Addendum No. 6, July 11th, 2025

Re: Johnson Hall Renovation – PKG 3
Johnson Hall Renovation & Foster Demolition
Tennessee Technological University
SBC Project No. 364/011-04-2022CM

A5.15

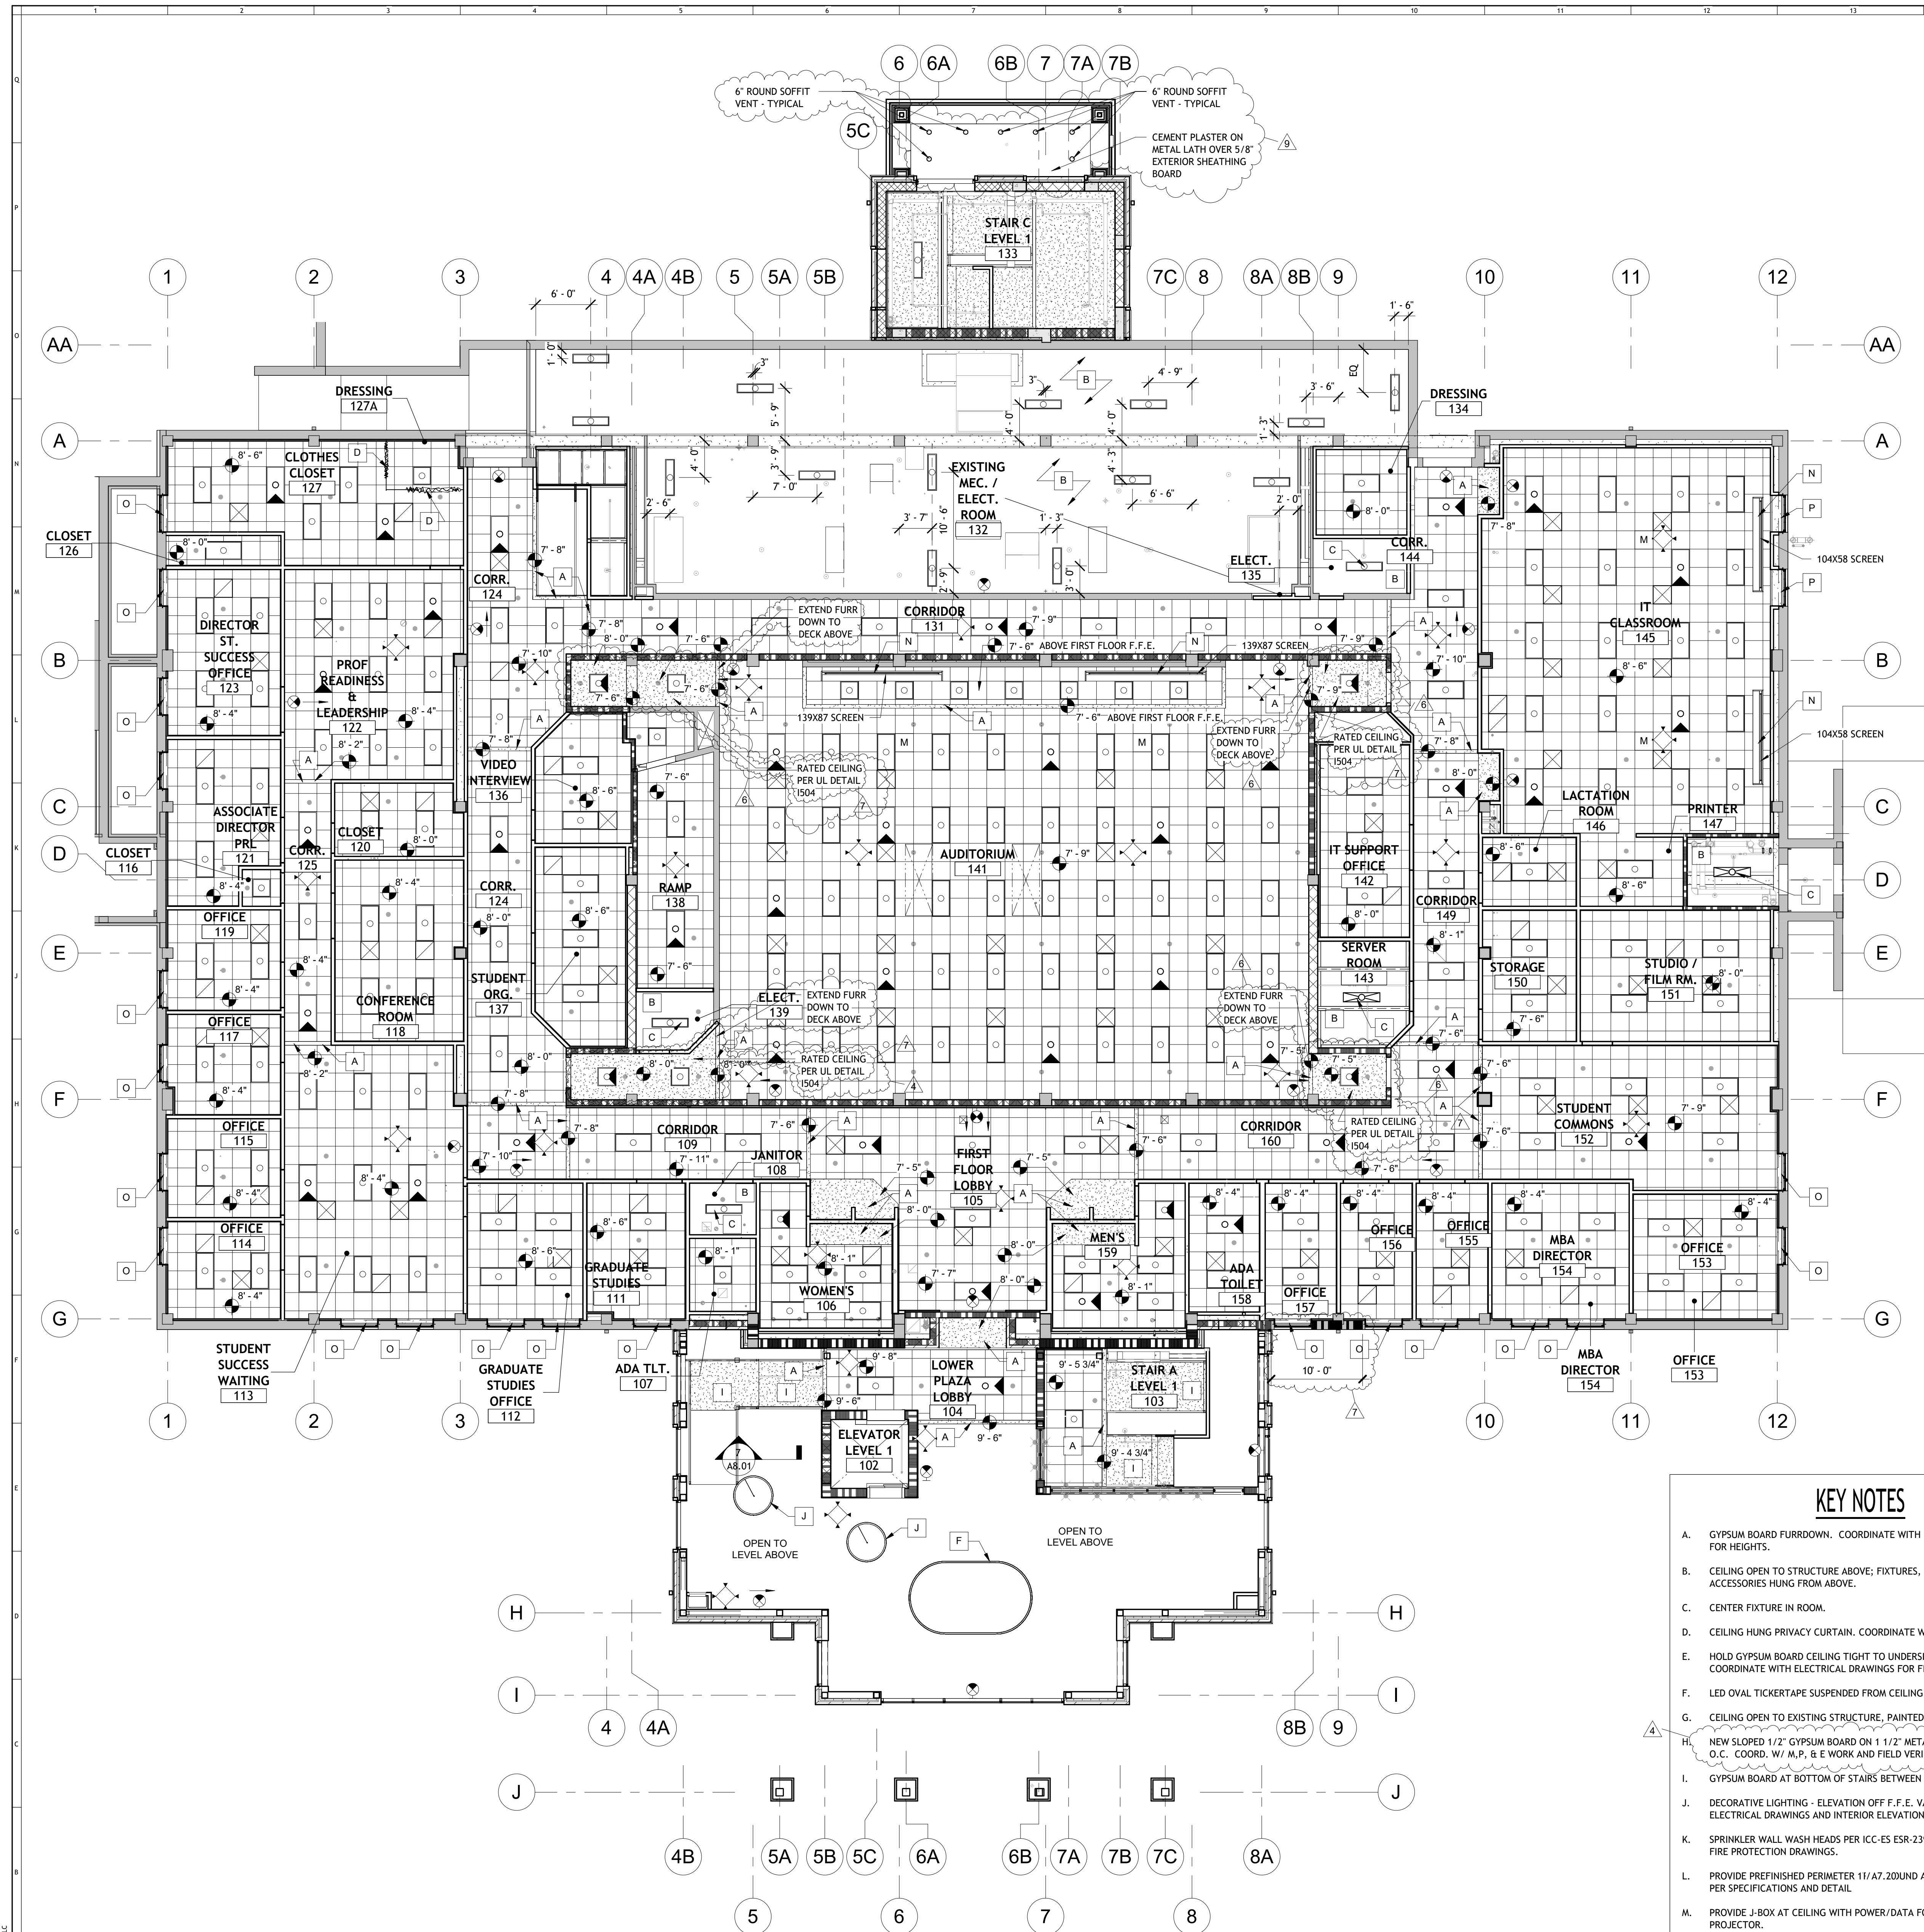
- 12) Refer to sheet A4.22 details 1 and 2. Change portico material to cement plaster on metal lath over 5/8" exterior sheathing board.
- 13) Refer to Sheets A5.12, A5.13, A5.14, and A5.15. Add prefinished metal eave vent applied to bottom of GFRP panel to locations shown on revised details.

- 14) Refer to sheets A5.12, A5.14 and A5.15. Change soffit at front portico, back portico and above exterior balcony to be a cement plaster on metal lath over 5/8" exterior sheathing board on 20 GA 3 5/8" metal stud framing @ 16' o.c.

JOB NO. 22025
ISSUE DATE: 3-28-25
SHEET TITLE: REFLECTED CEILING PLANS - FIRST FLOOR
DRAWN: CWD
REVIEW: KAC
A7.10

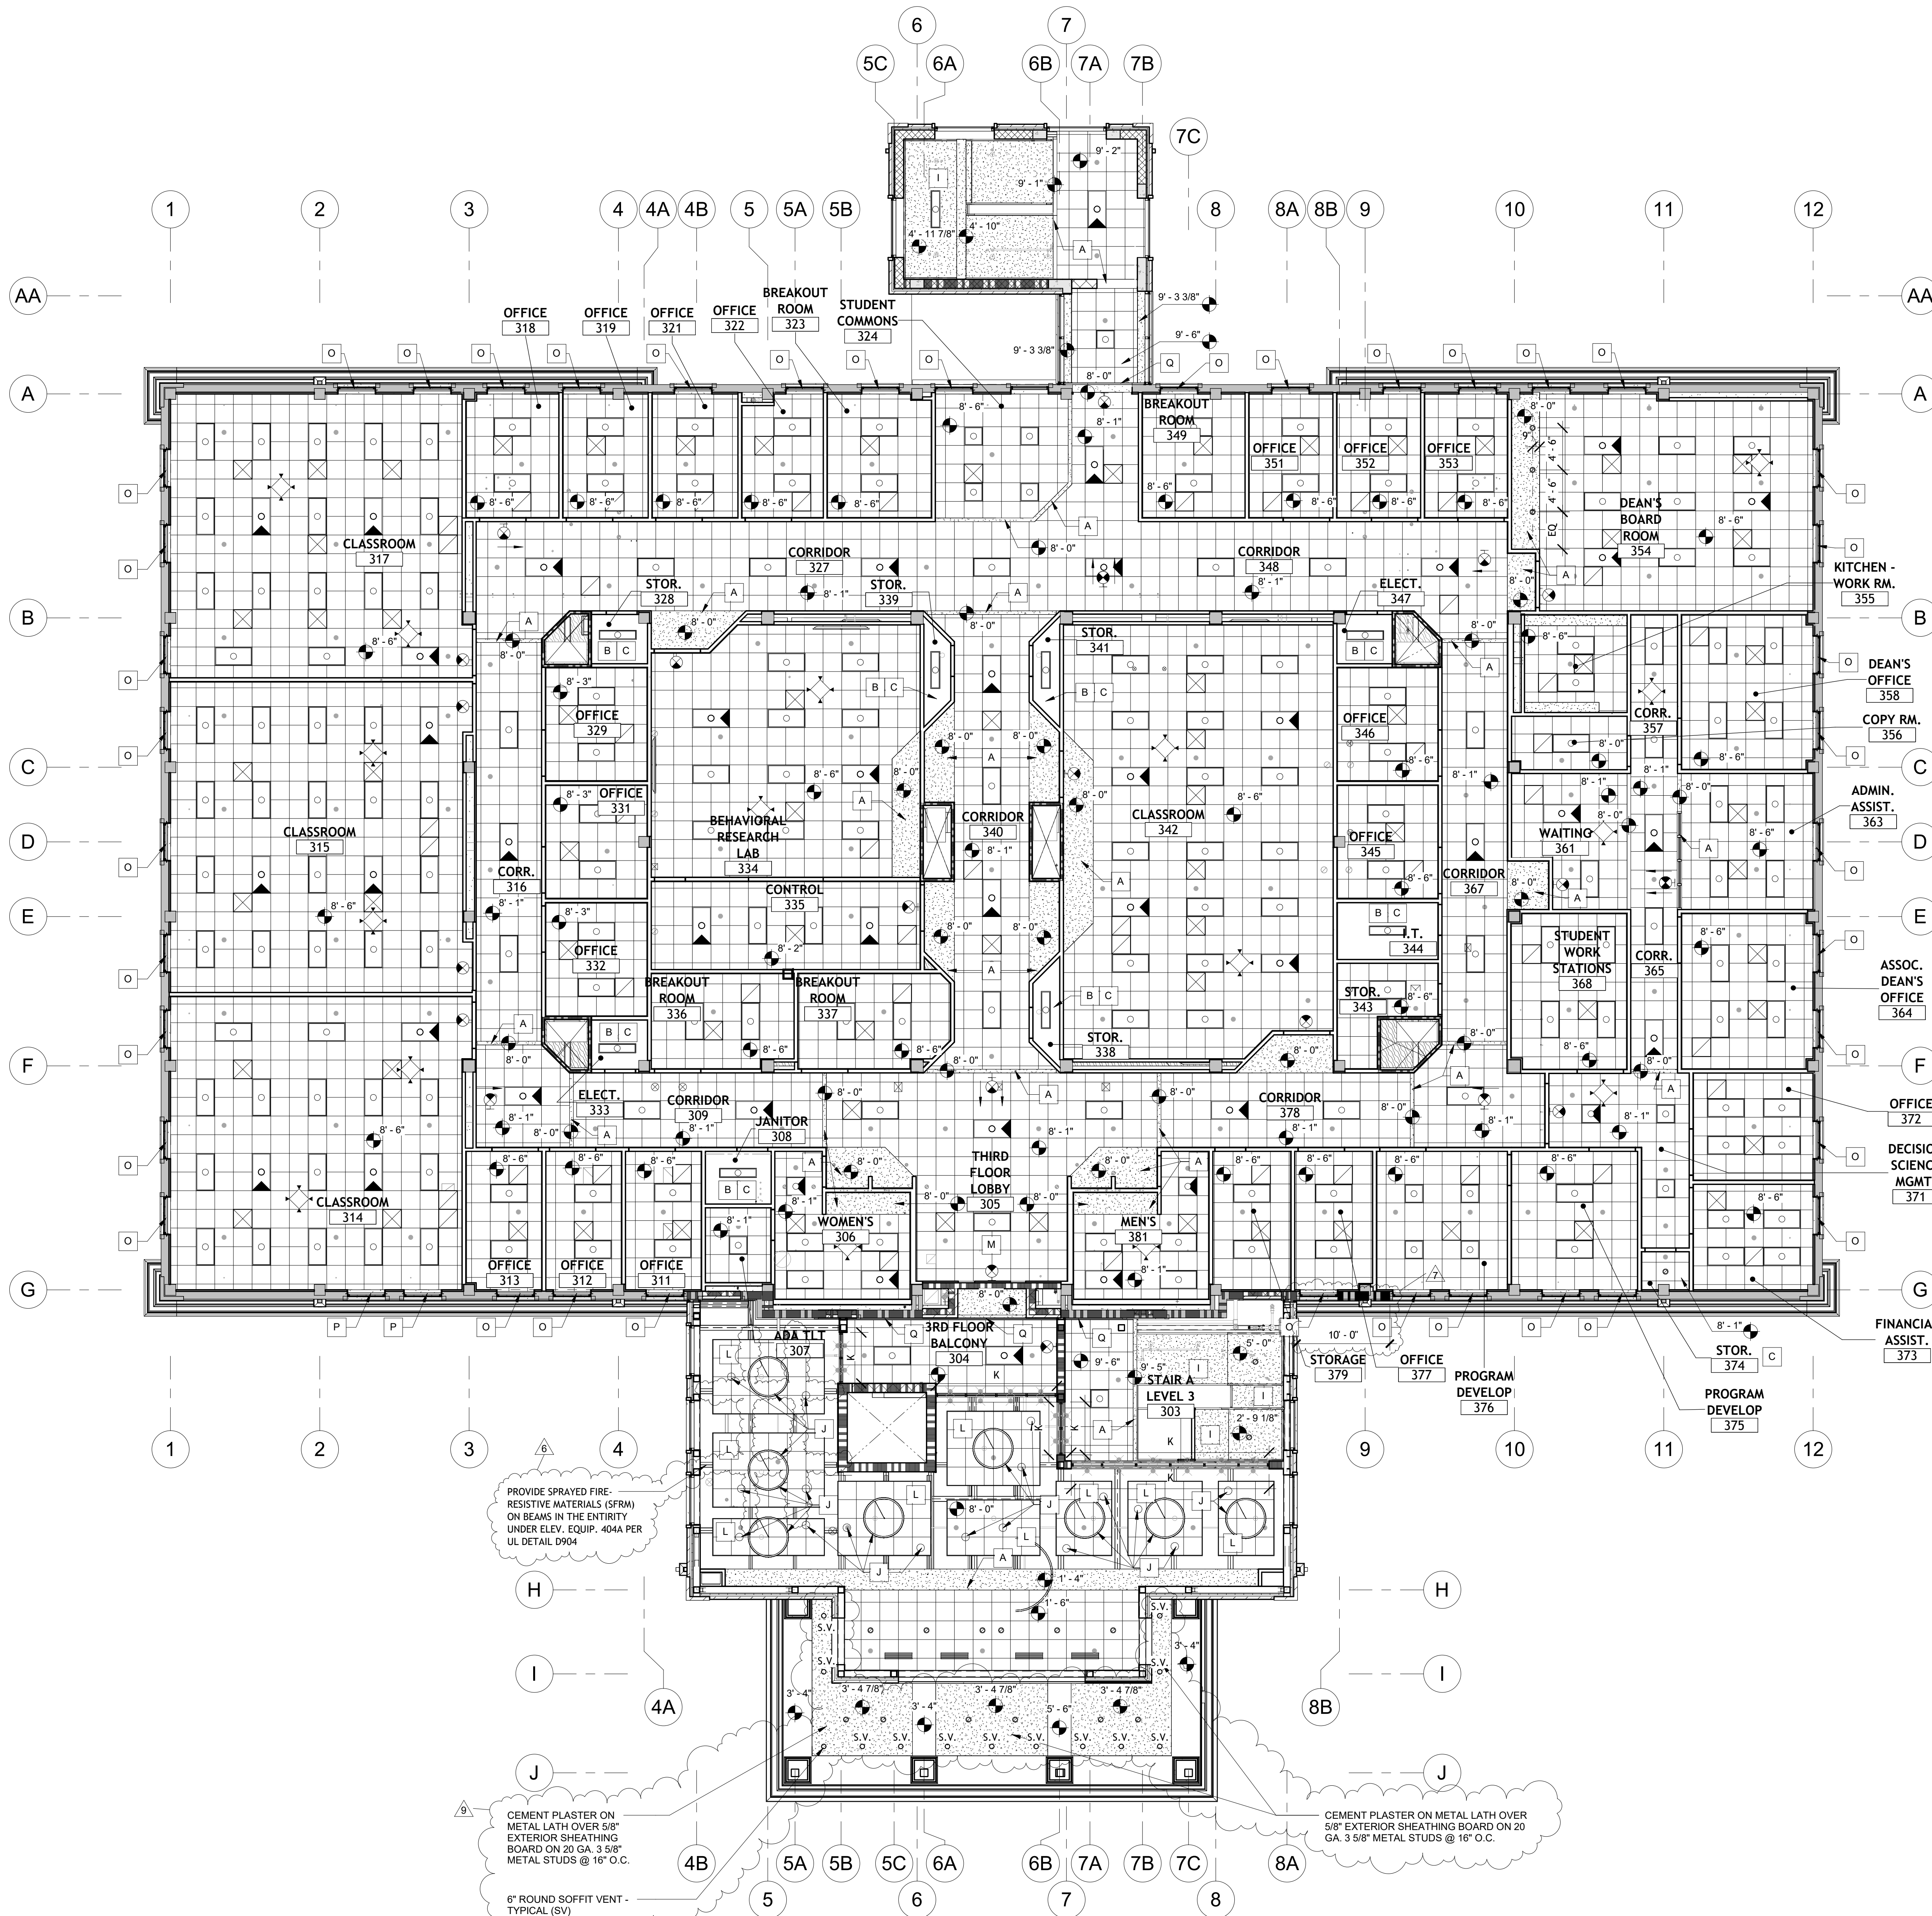
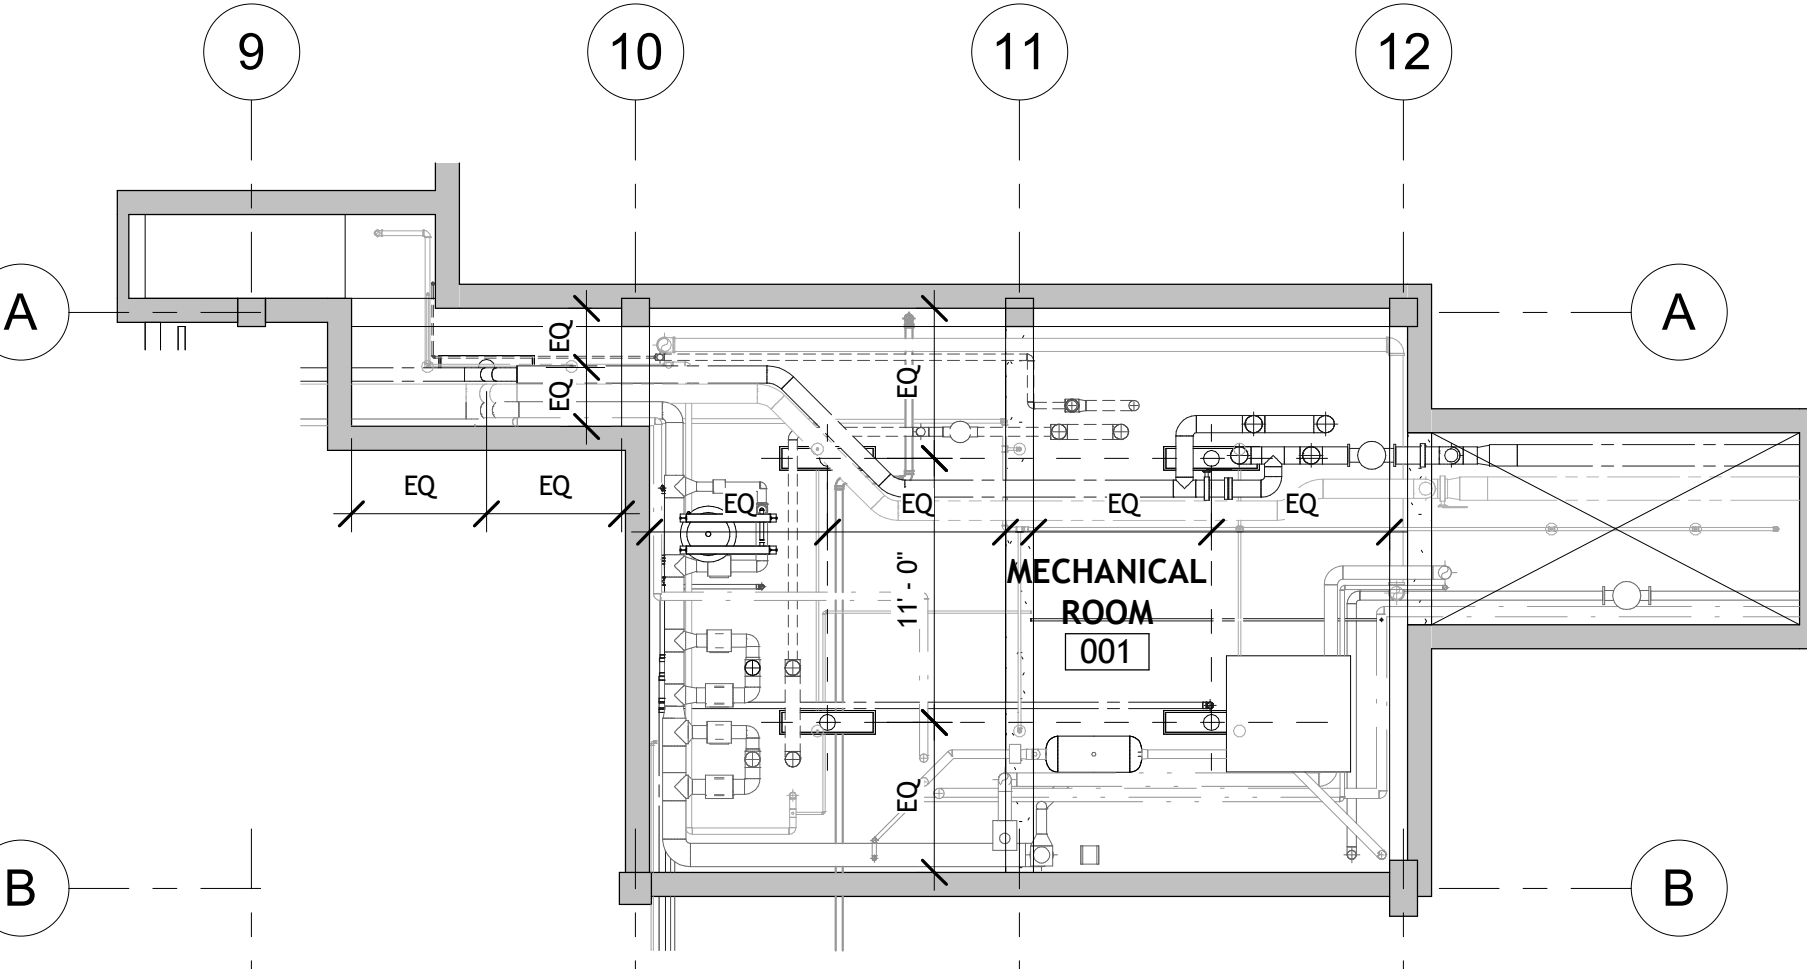
- 15) Refer to sheets A7.10, A7.30 and A7.40. Change soffit at front portico, back portico and above exterior balcony to be a cement plaster on metal lath over 5/8" exterior sheathing board on 20 GA 3 5/8" metal stud framing @ 16" o.c. Add 6" round soffit vents as shown on revised drawings.
